# Meath County Council Athboy Town Centre Project

DMURS Quality Report

## DMURS Quality Audit

Document Control Sheet	
Document Reference	11084 – DMURS Quality Report
Report Status	Issue
Report Date	January 2022
Current Revision	D00
Client:	Meath County Council
Client Address:	Buvinda House, Dublin Road, Navan, Co. Meath, C15 Y291
Project Number	11084

### Issue 6.2:

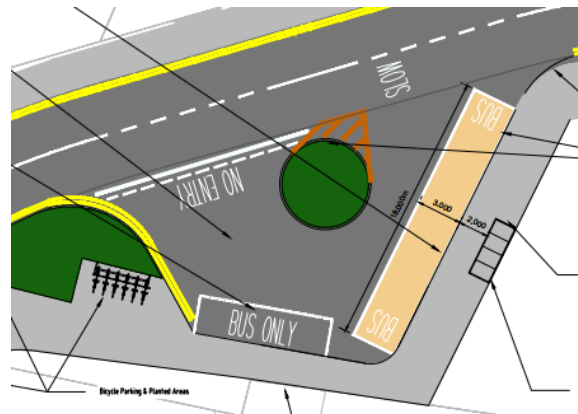
Currently in Athboy there is a significant issue regarding accessibility and safety of pedestrians to use the existing bus stop facility. There exists no provision of facilitating less abled users, visually impaired users, or luggage storage at the existing location where pedestrians are forced

to walk onto the National Secondary Road to embark/disembark from the Public Transport Facility

Full height kerbing to be provided on both sides of the side street to deter cars from mounting kerbs. Removal of undesignated parking along South side of the Side Street to change behaviour. Inclusion of Yellow Box and colour change Raised Table will deter road users from parking along the Main Street / Side Street Junction while formalising Public Car Park will encourage use as a public facility compared to the existing 3 entrance scenario that exists.

*Plate 2-2: Proposed Bicycle Parking*

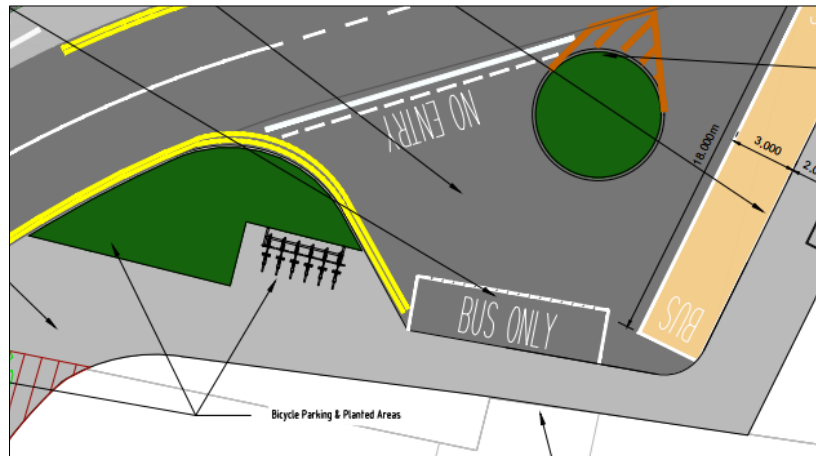
It is noted no facility is provided for cyclists to access the bicycling parking from the road level onto the footway. Dismounting cyclists in proximity to a parked bus may lead to collisions between cyclists and buses.

The design team should provide facilities for cyclists to transition from the road level to the bicycling parking located on the footway away from parked and moving buses.

Plate 2-4: Proposed Tactile Paving within Car Park

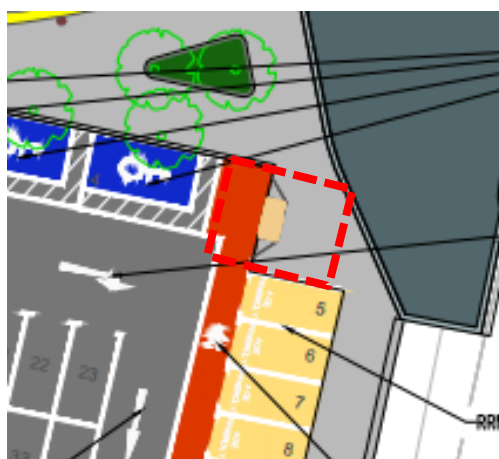
A single tactile paving is proposed with the drop kerb beside the disable parking. However, there is no second tactile paving in line with the direction of travel. This will guide a visually impaired person into a parked vehicle and may lead to a collision between the visual impaired pedestrian and a vehicle.

The design team should remove the proposed tactile paving at this location.

*Plate 2-5: Proposed Yellow Box on the N51*

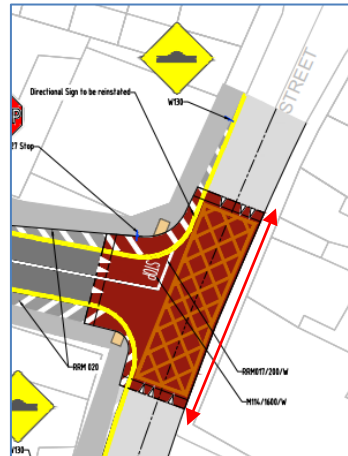
After a review of the autotracks provided the audit team are concerned the length of the proposed yellow box may result in driver frustration. Vehicles on the mainline may enter the yellow due to its length causing obstruction for vehicles entering/exiting the minor road. This may lead side-on collisions.

Plate 2-8: Proposed 75mm Drop Kerb

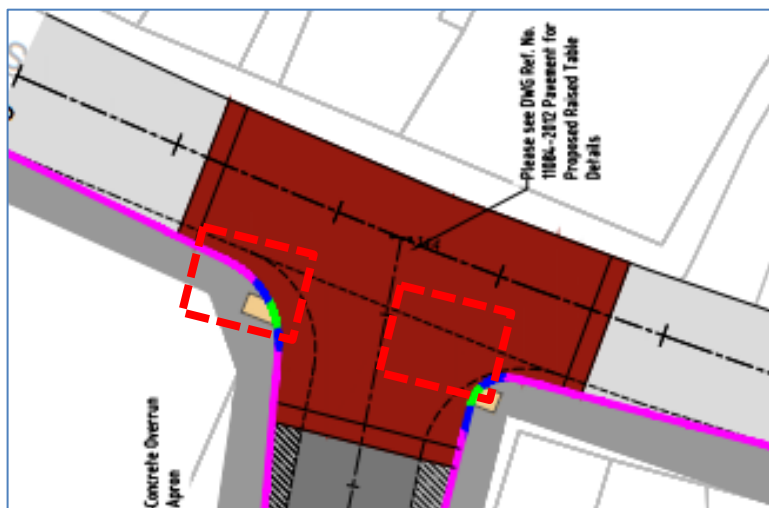
The Road Safety Audit Team note on Drawing 11084-2012 a proposed 75mm drop kerb at the raised table. A step in level over 6mm may result in pedestrians tripping into the carriageway into oncoming traffic.

*Plate 2-9: Proposed Post and Rail to Car Park*

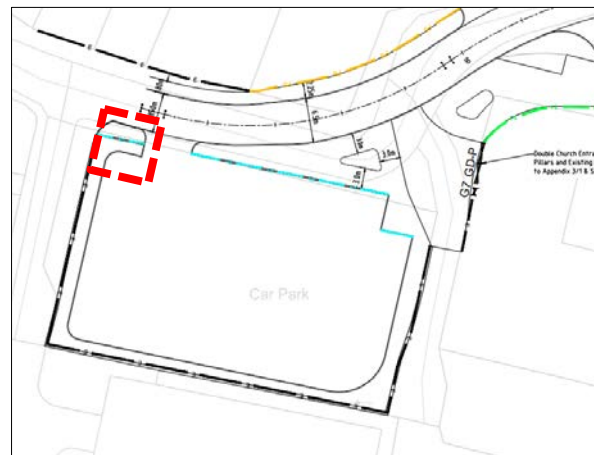
The Road Safety Audit Team note on Drawing 11084-2008 it is proposed to run a new post and rail fence along the north of the car park. The audit team are concerned pedestrians travelling from the west along the footway will enter into the carriageway at the car park junction to access the internal footway within the car park layout. Pedestrians on the carriageway will be in conflict with vehicles resulting in a collision.

The design team should implement measures or design changes to provide for vulnerable road users desire lines.

*Plate 2-13: Proposed Pencil Bollards*

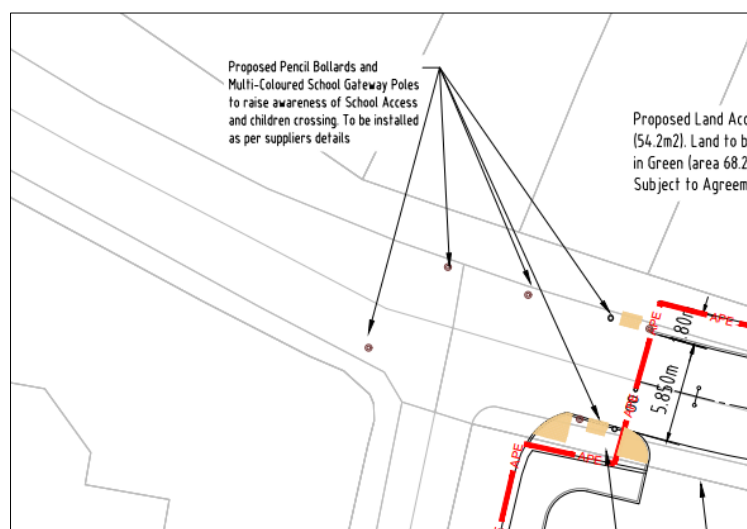
The audit team observed has works proposed by the Designer outside the Area Provided the Employer and scope of this RSA.

Drawing No.: 11084-2019

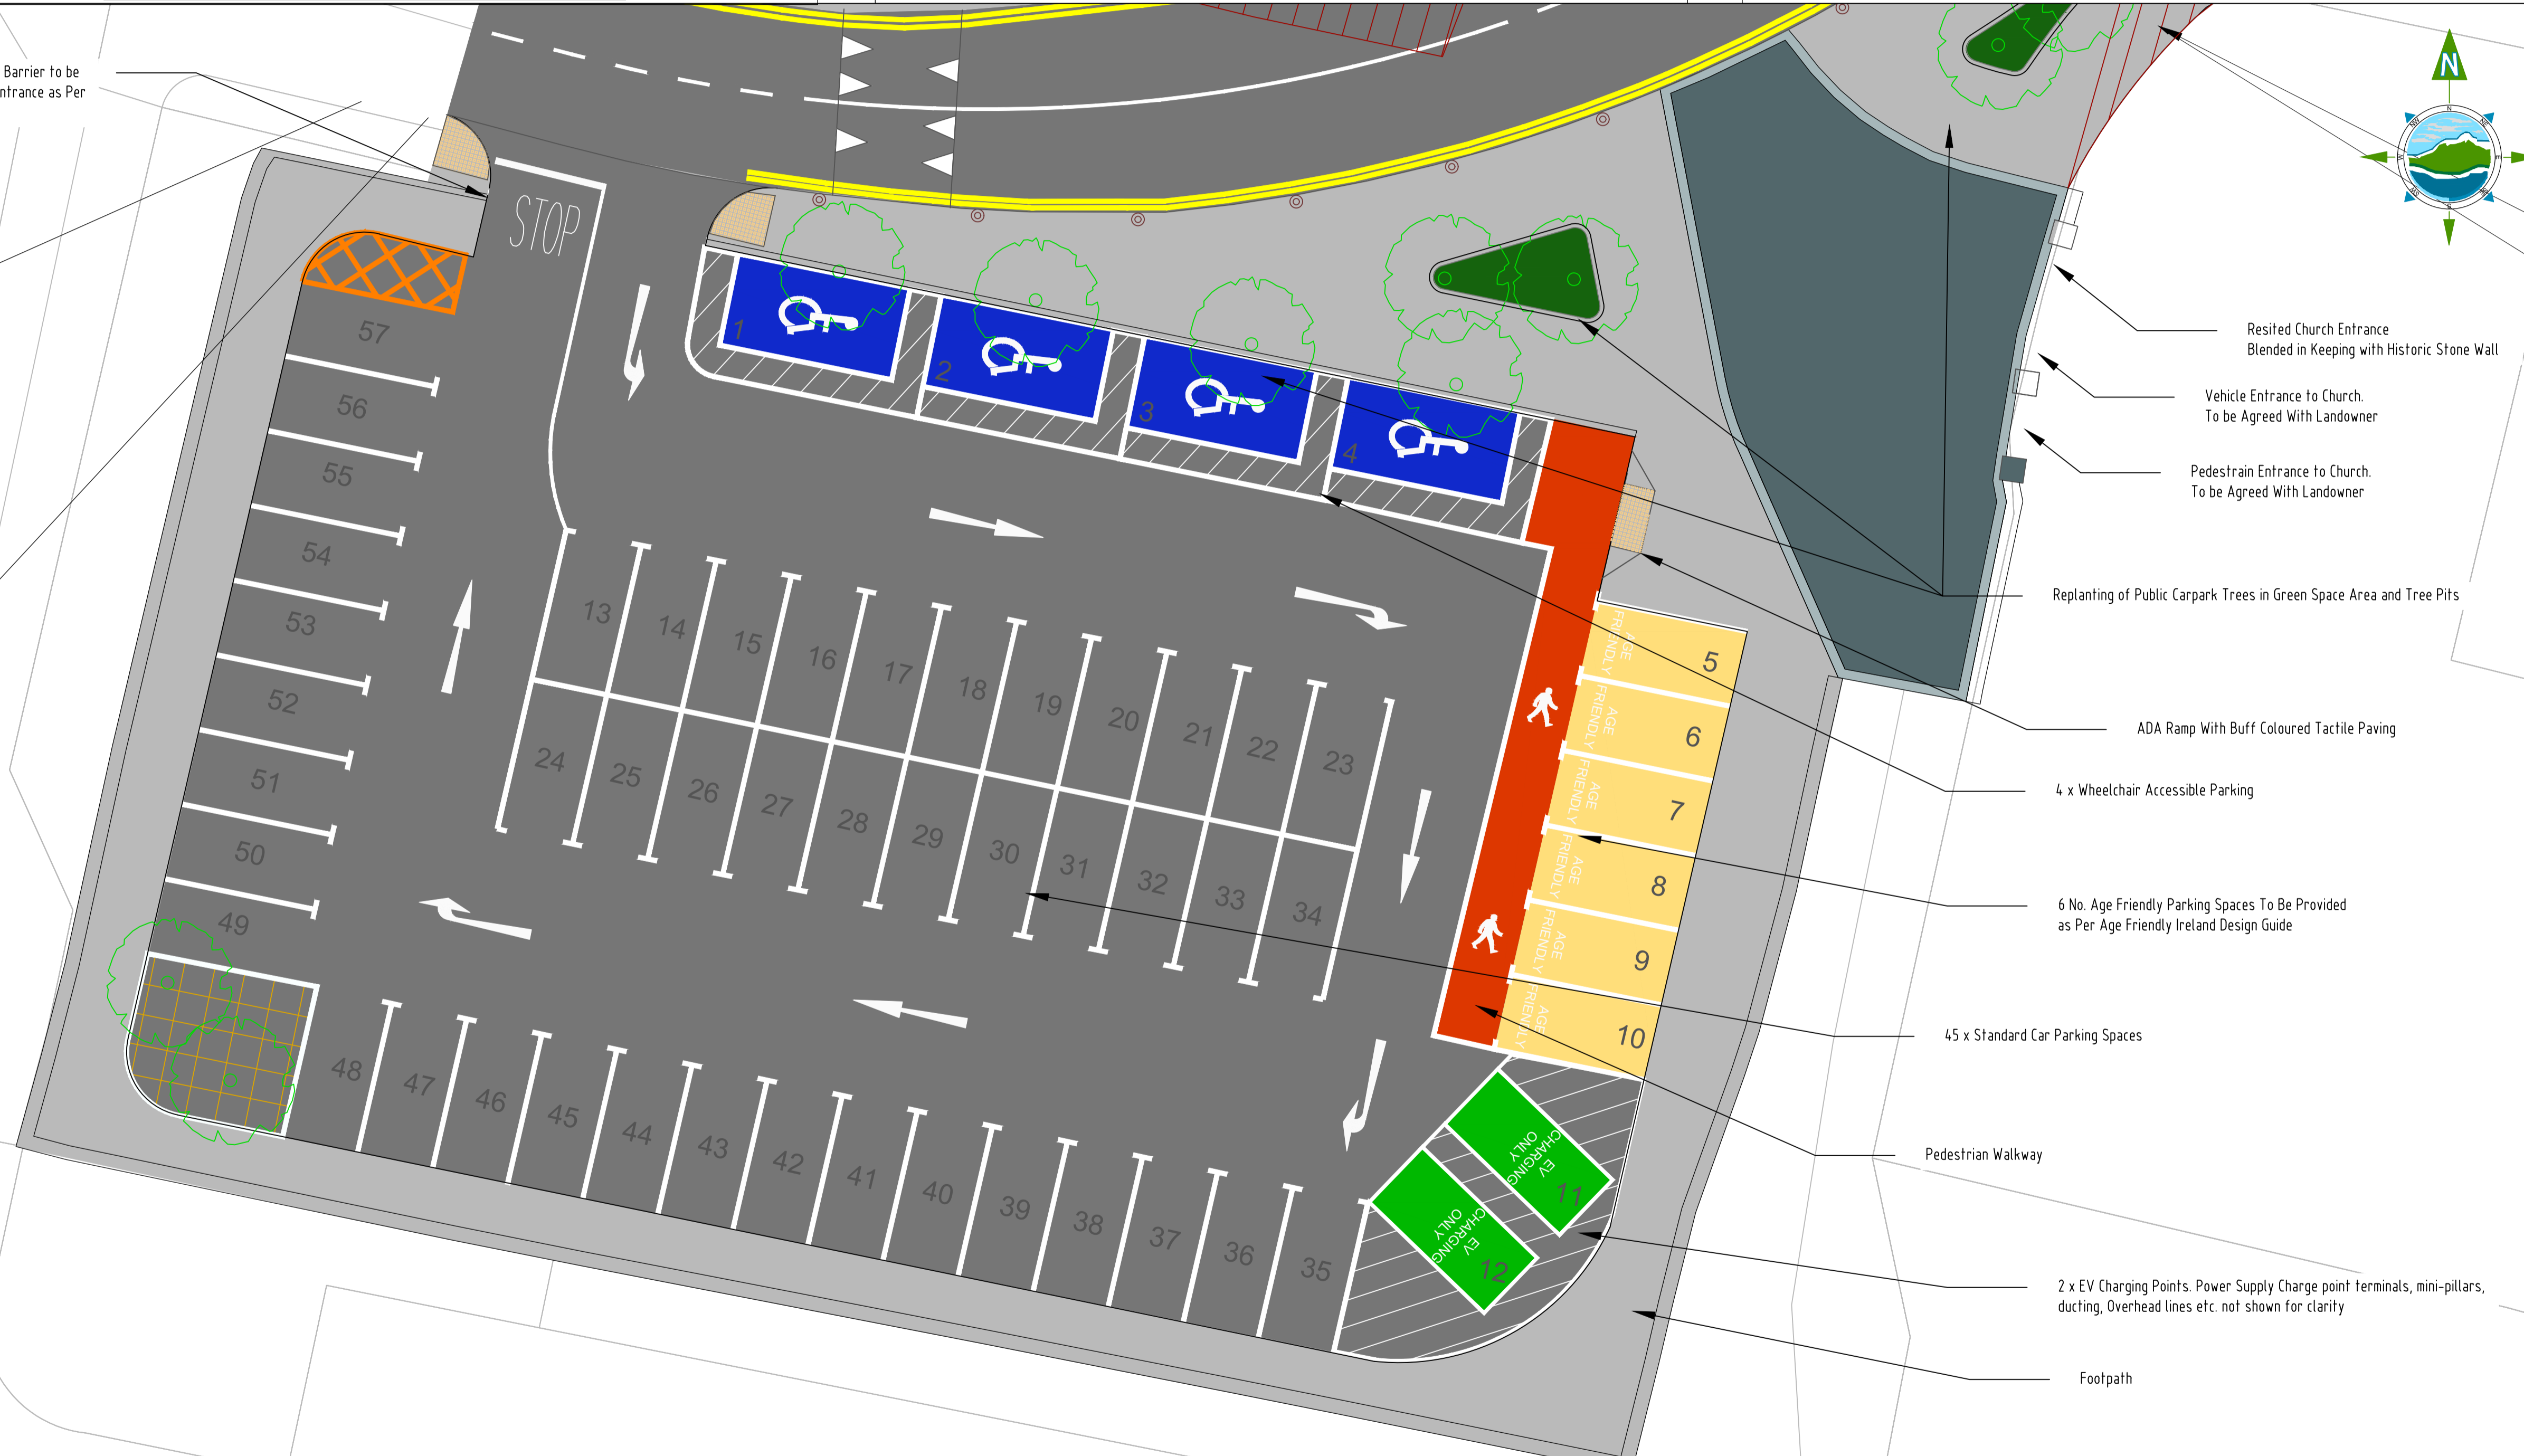
The Road Safety Audit Team note on Drawing No. 11084-2019 a walkway is proposed west of the age friendly parking spaces. The Audit Team are concerned this will result in vulnerable road users being struck by vehicles when reversing. The swept path analysis also shows vehicles encroaching into this walkway.

The design team should remove the pedestrian walkway.
